Car Stereo  
Service Bulletin

**Model:** XK-8D

**No.** 107

**Subject:** Direction May Change During Playback

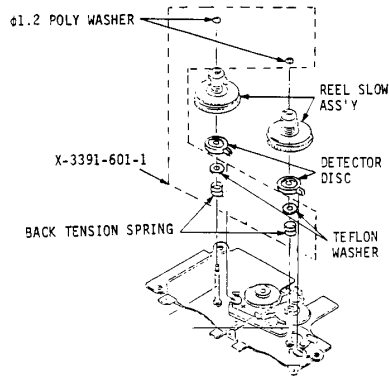
**Symptom:**  
(262)

The back tension spring is weak, so the detector link lever is unstable. Another cause may be the back tension spring is hooked at the detector disc.

**Solution:** Replace the back tension spring and add a teflon washer between the back tension spring and detector disc as shown.

**Note:** When installing the detector disc, the protruded portion must be aligned as shown.
